ADDENDUM NO. 1
TO
PROCUREMENT AND CONTRACTING REQUIREMENTS
FOR
NineStar CR200 Sewer – Division I
FOR
NINESTAR CONNECT
Issue Date: October 25th, 2023

The following, as additions to and modifications in the Bidding Requirements and Contract Documents, will be included in, and become a part of the **NineStar CR200 Sewer – Division I**. This Addendum forms a part of the Contract Documents. Bidders are, therefore, instructed to take the following into account in rendering any Bid for this work. Acknowledge receipt of this Addendum in the space provided on the Bid Form.

PUMP CONTROL PANEL SWING DOOR VIEW

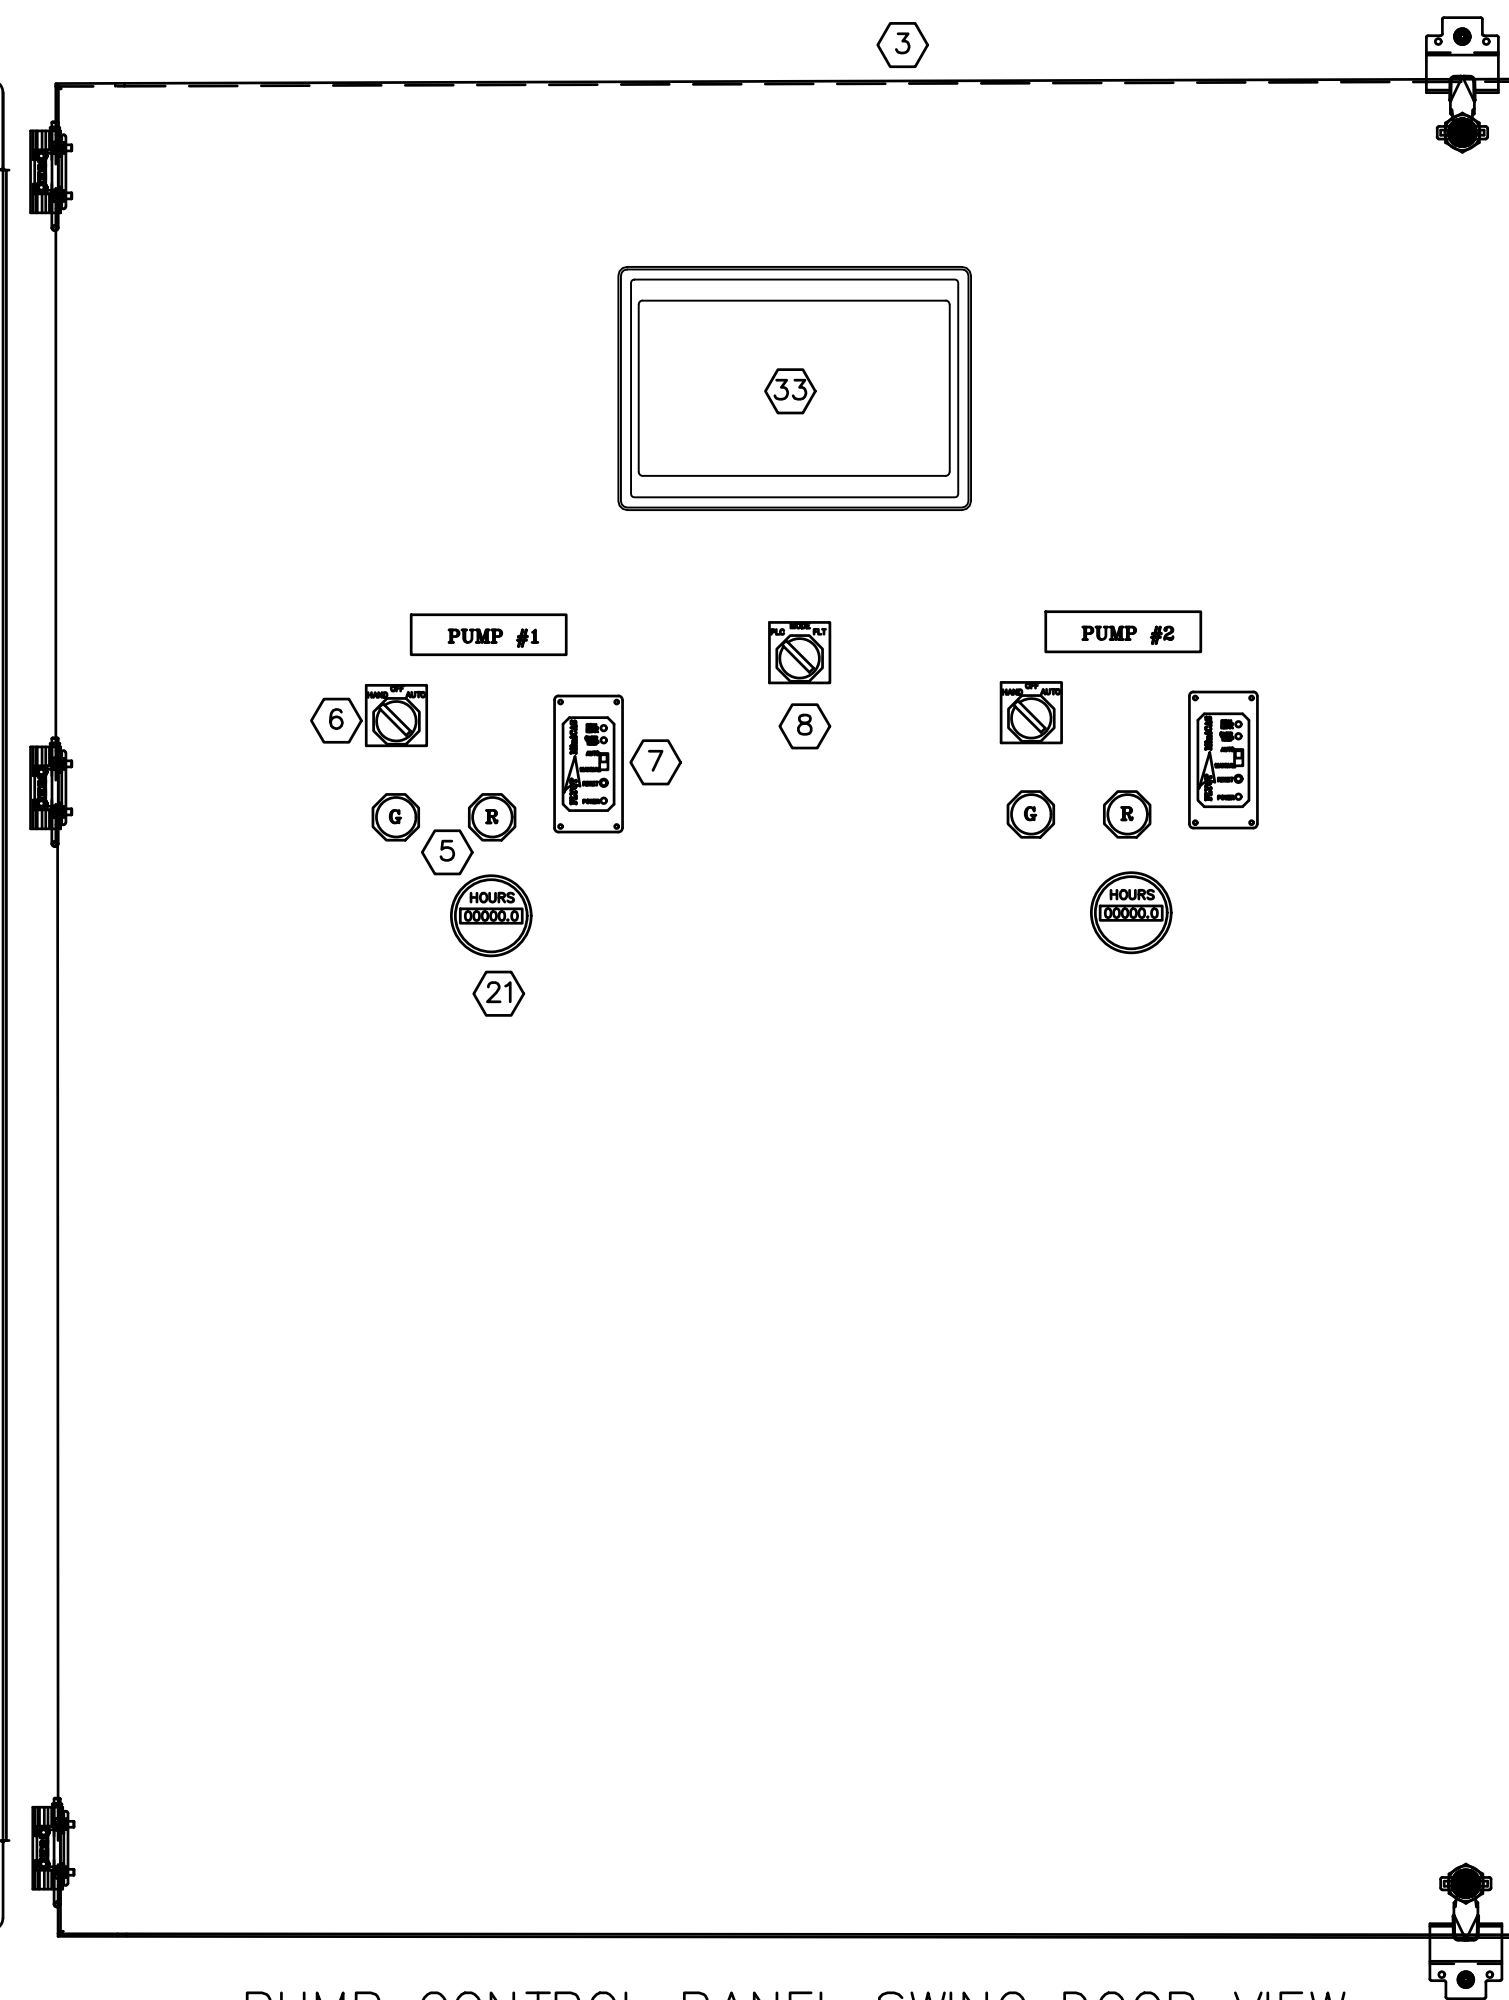
- s. Sheet E402 – Sugar Creek Lift Station Electrical Details (Coupling in vented channel removed.)
- t. Sheet E403 – Sugar Creek Pump Control Panel Layout Details (Added note about AC/Unit heater.)

E404

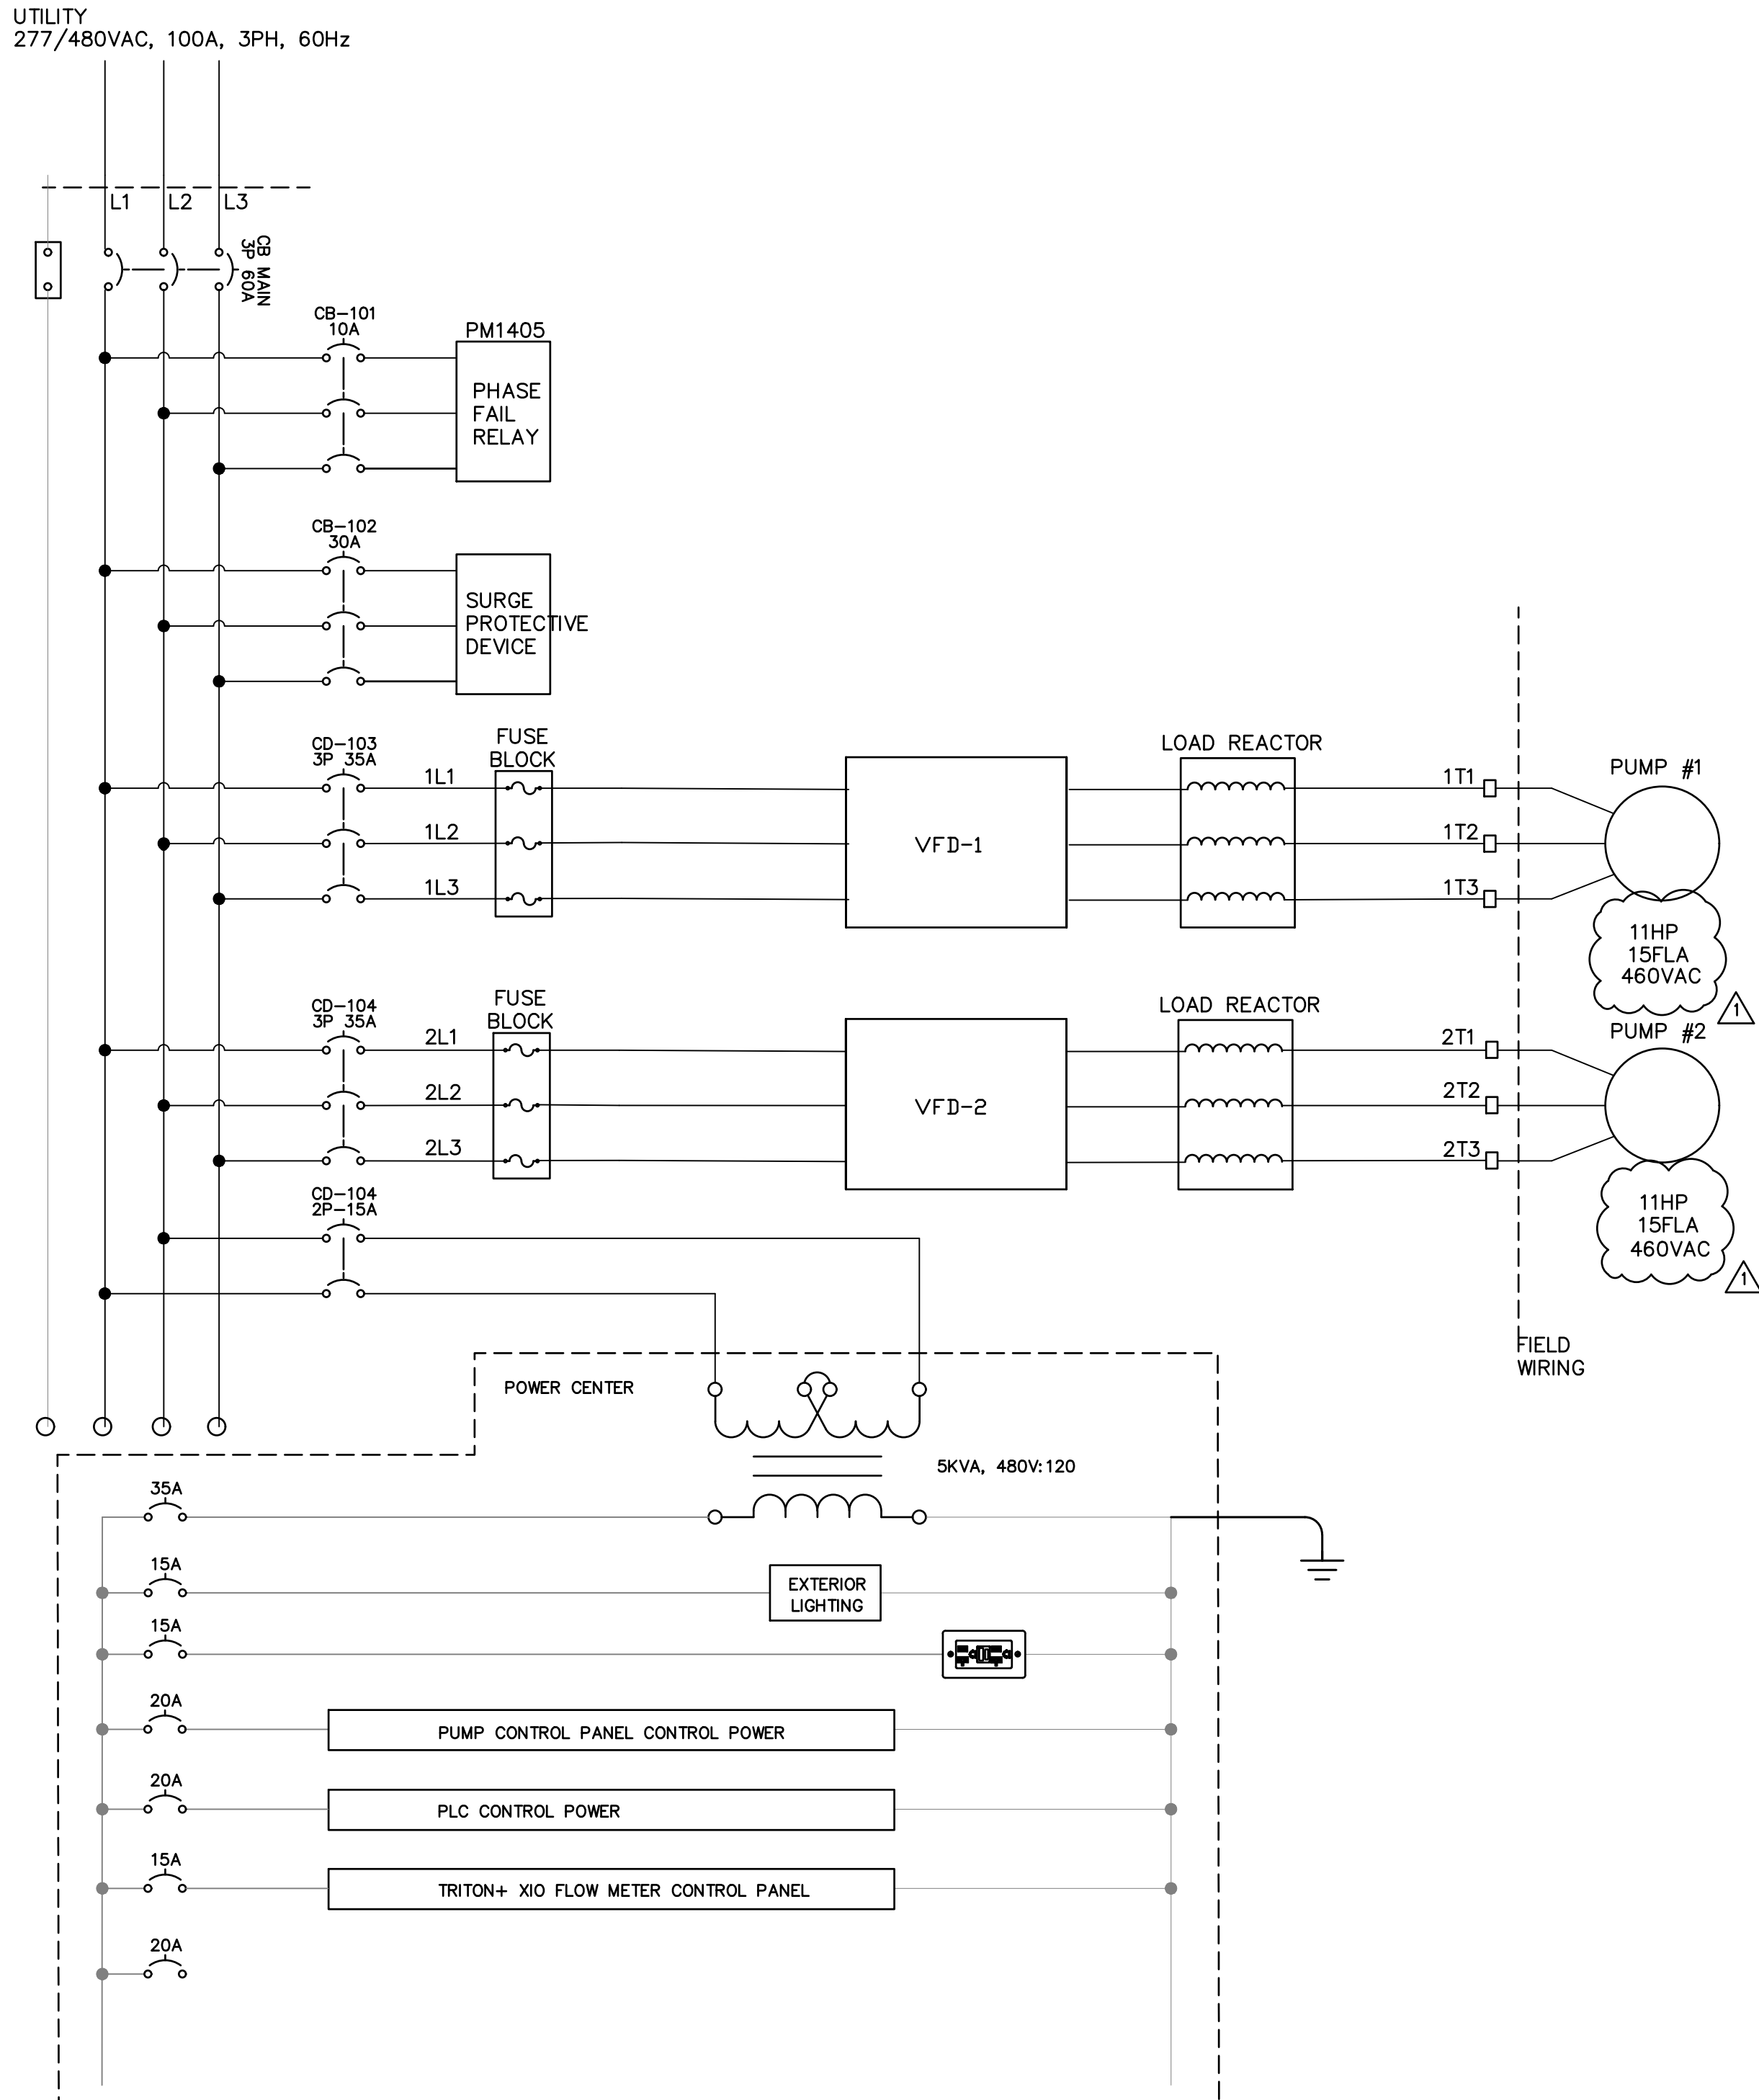
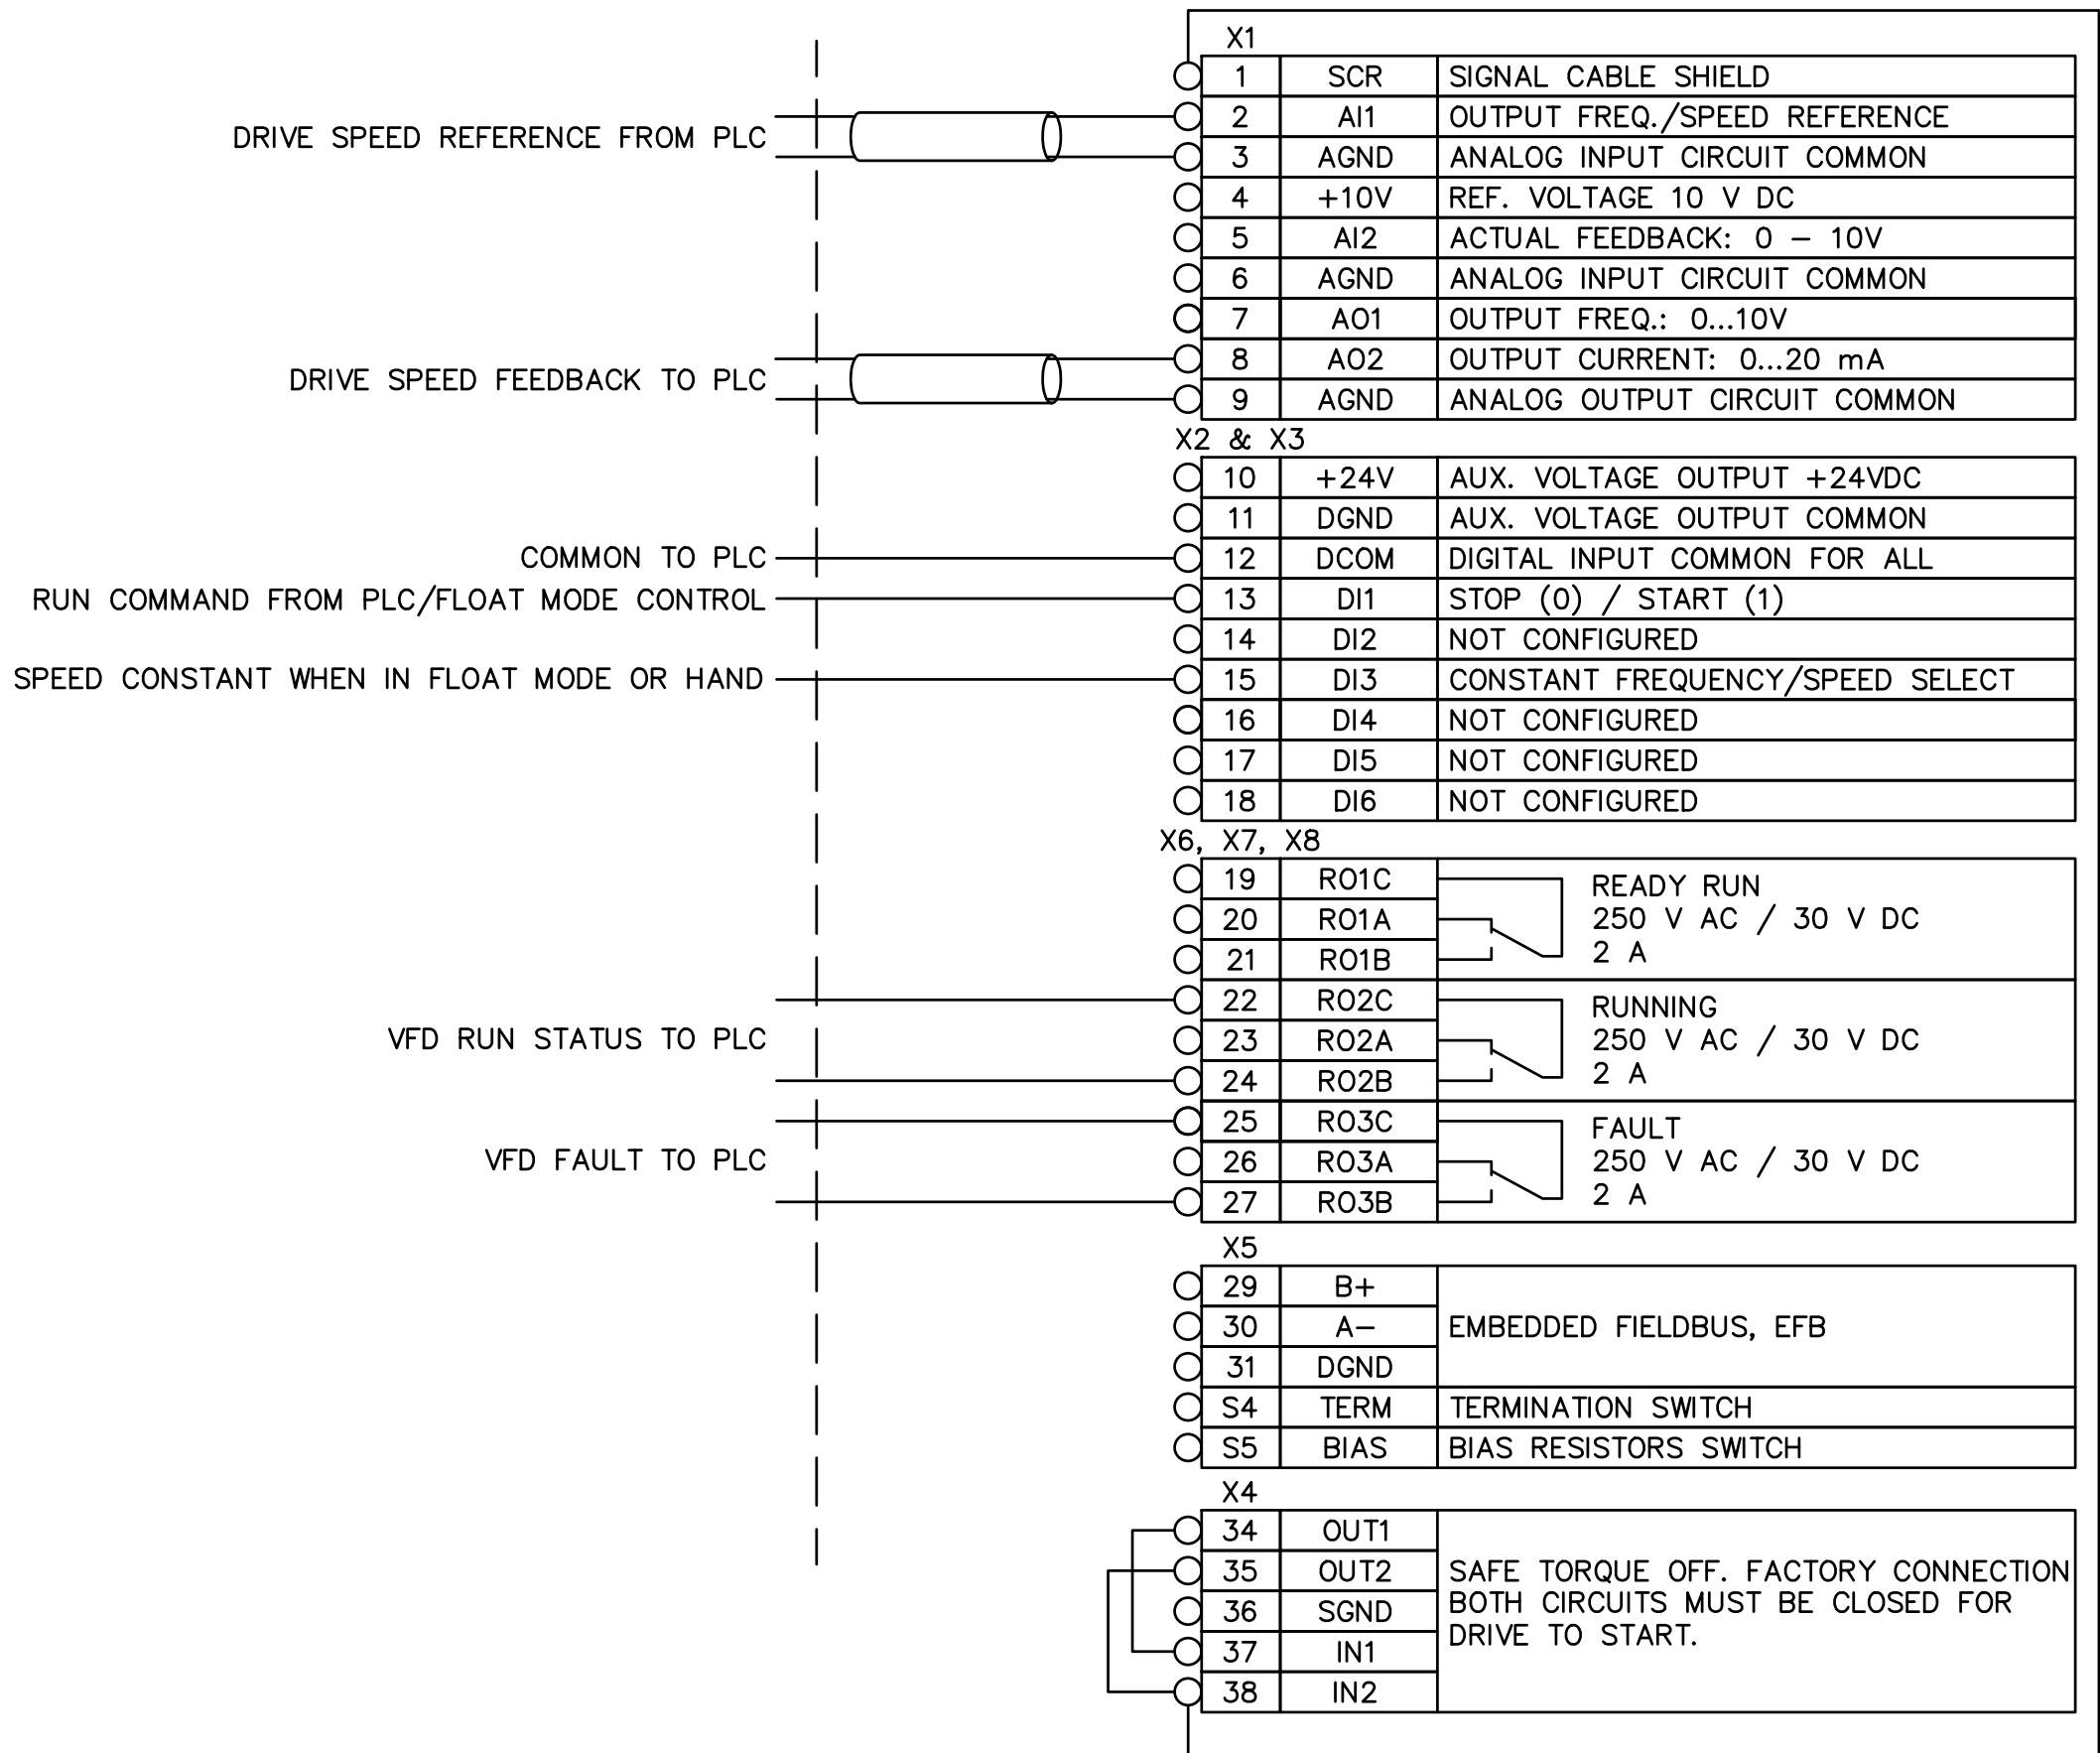
- u. Sheet E404 – Sugar Creek Pump Control Panel Wiring Details (Updated pump FLAs)
- v. Sheet E405 – Sugar Creek Pump Control Panel Wiring Details Cont (OL1 and OL2 removed as there is no motor starter. Removed “pilot light” from alarm beacon circuit note.)
